## Executive Director's Recommendation

Commission Meeting: March 1, 2018

<b>PROJECT</b> <b>Thomas Jefferson Memorial - Targeted Accessibility Improvements</b> 16 East Basin Drive, SW Washington, DC	<b>NCPC FILE NUMBER</b> 7937
	<b>NCPC MAP FILE NUMBER</b> 1.51(73.10)44660
<b>SUBMITTED BY</b> United States Department of the Interior National Park Service	<b>APPLICANT'S REQUEST</b> Approval of comments on concept design
<b>REVIEW AUTHORITY</b> Federal Projects in the District per 40 U.S.C. § 8722(b)(1) and (d)	<b>PROPOSED ACTION</b> Approve with comments on concept design
	<b>ACTION ITEM TYPE</b> Consent Calendar

# Thomas Jefferson Memorial Targeted Accessibility Improvements

## Proposed Design: Sloped Walkway outside Existing Planter

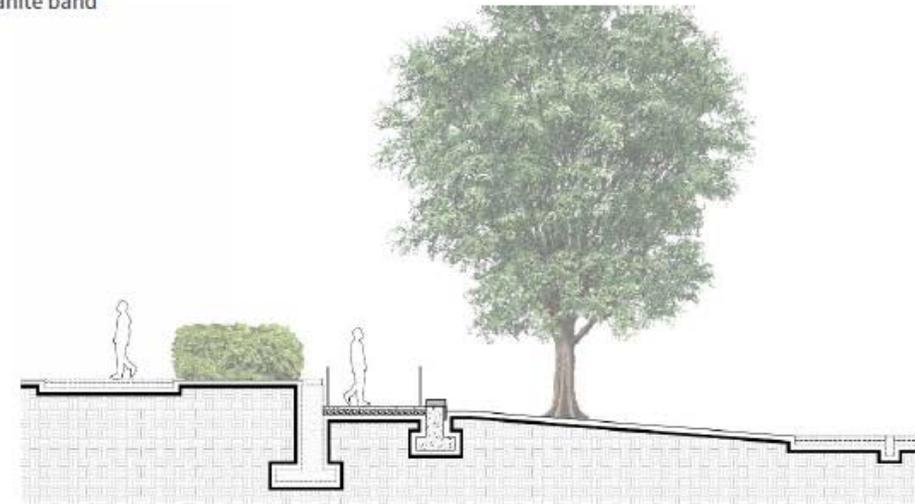
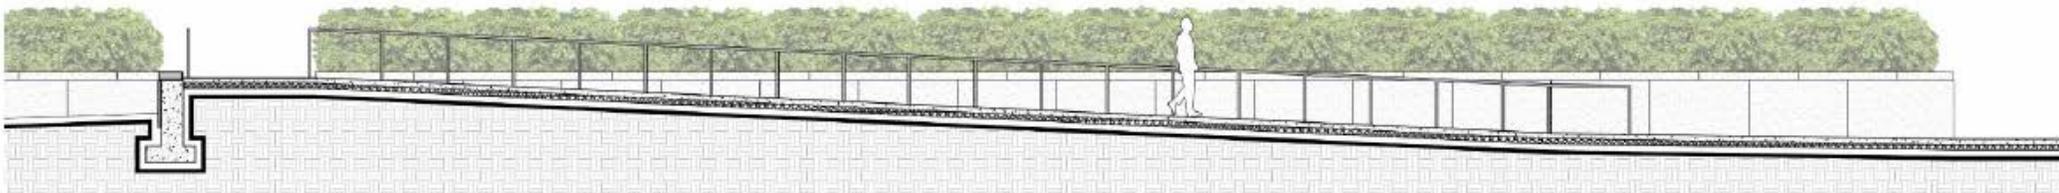
The U.S. Commission of Fine Arts reviewed the concept proposal at their February 15, 2018 meeting, supporting NPS's preferred option of the new accessibility ramps to be constructed outside the existing historic planters, but encouraged NPS to explore removing the external handrail by leveling the adjacent ground with the ramp and by relocating the internal handrail to the top of the historic terrace planter.
